STS-122 Integrated Launch Site Requirements Review

PRCB Presentation

STS-122 LSRR OV-103 FLIGHT 34 CONFIGURATION UPDATES

STS-122 OV-103 Flt 34 – LSRR Updates

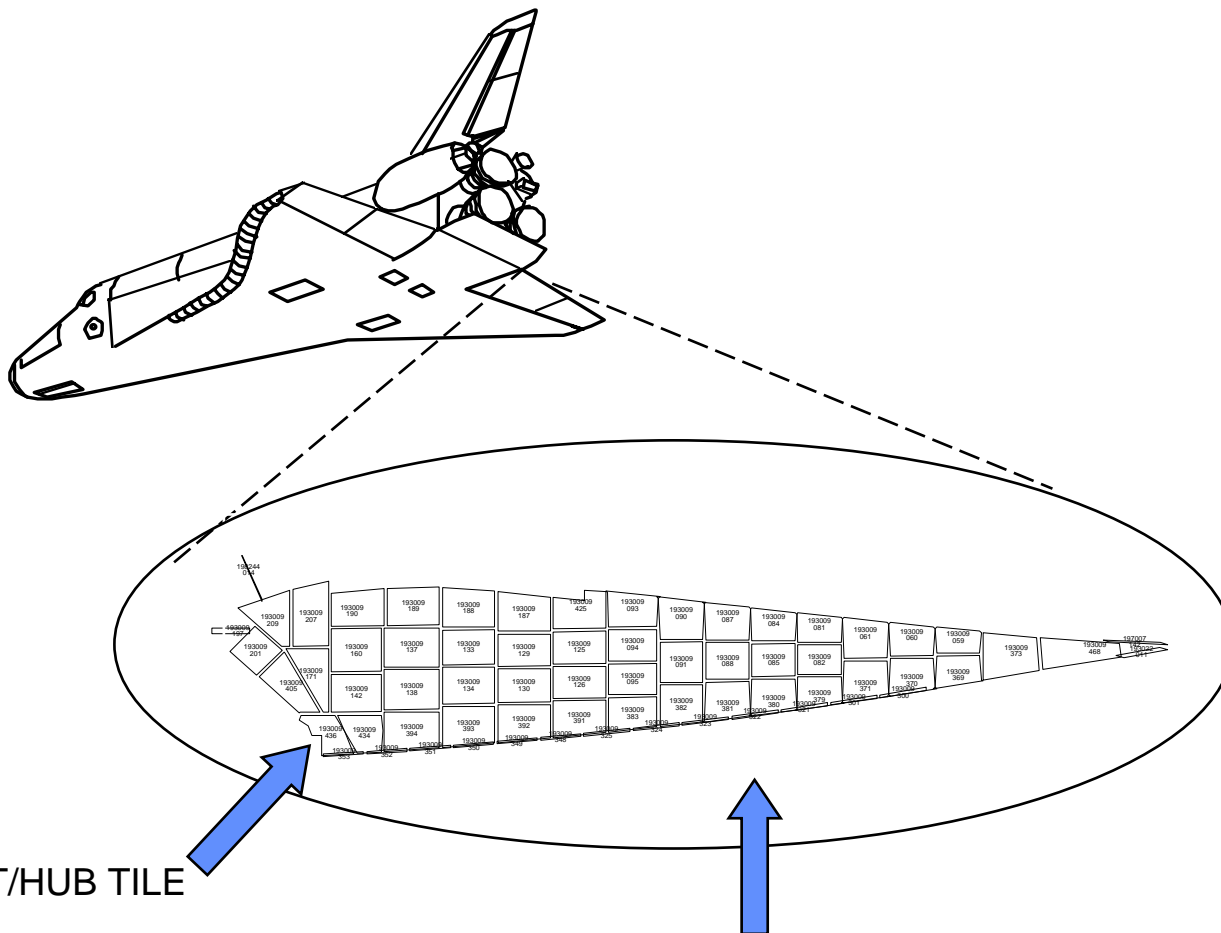
Connector savers have been found in the fleet with incorrect interfacial seal and retention force too low to insure proper locking following installation. Remaining implementation locations for this mod include OMS Pod interface and Ku-Band (T-0 and ET Umbilical Monoball locations implemented during STS-114 flow).

Connector Saver mod approved to provide proper interfacial seal and wavy washer engagement retention force to reduce risk of inadvertent demate during use

Hub Tile (Cont.)

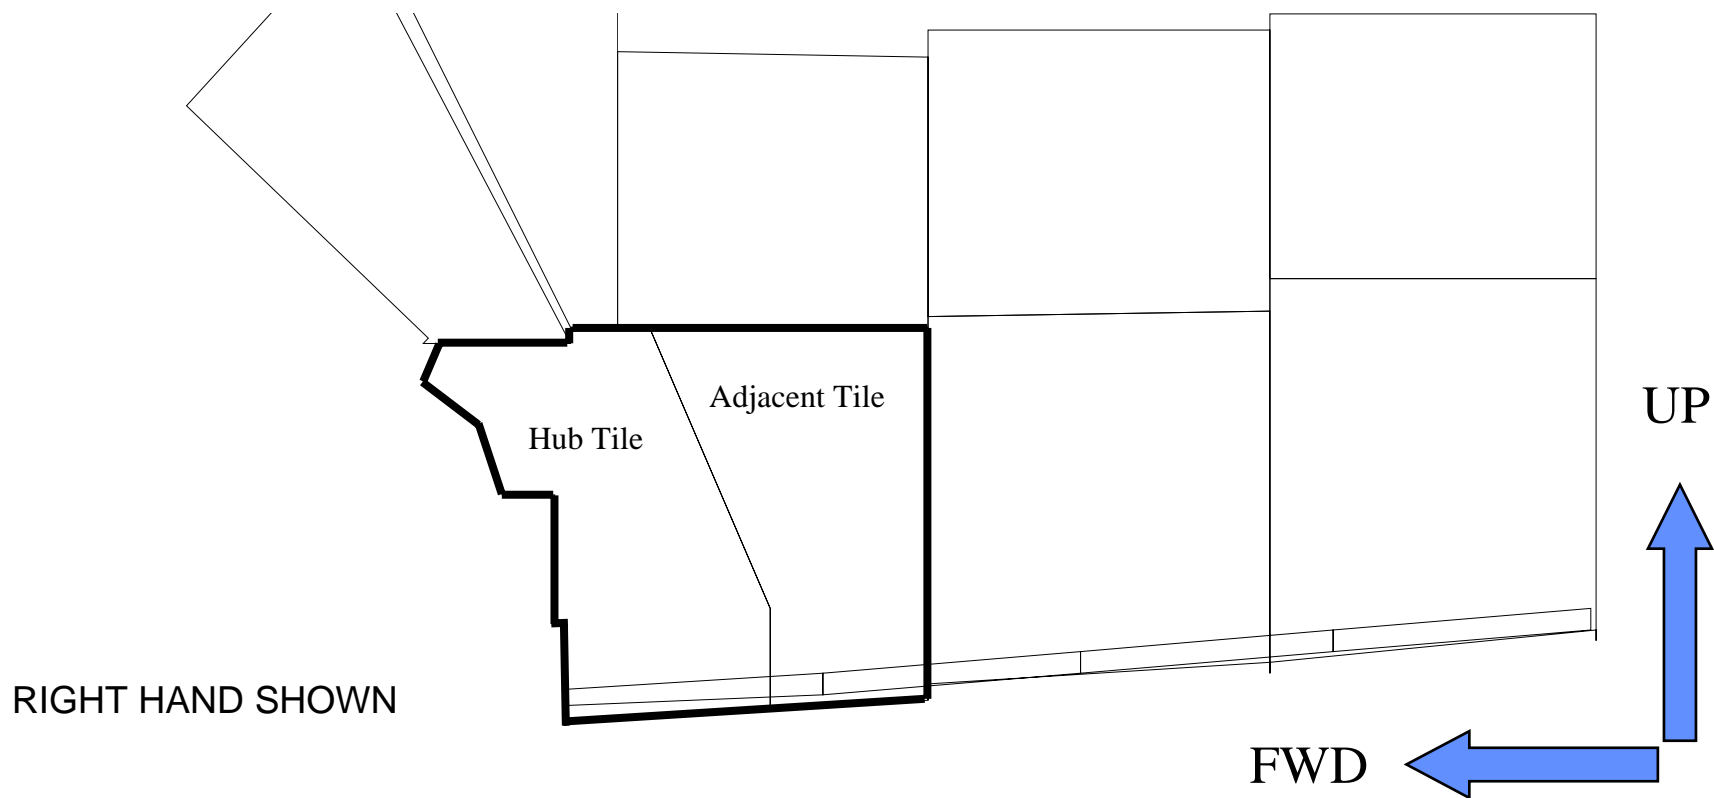
Replaces 2 tiles in the inboard elevon area with a single more robust tile. Previous design could lead to installation errors which could result in loss of tile in flight.
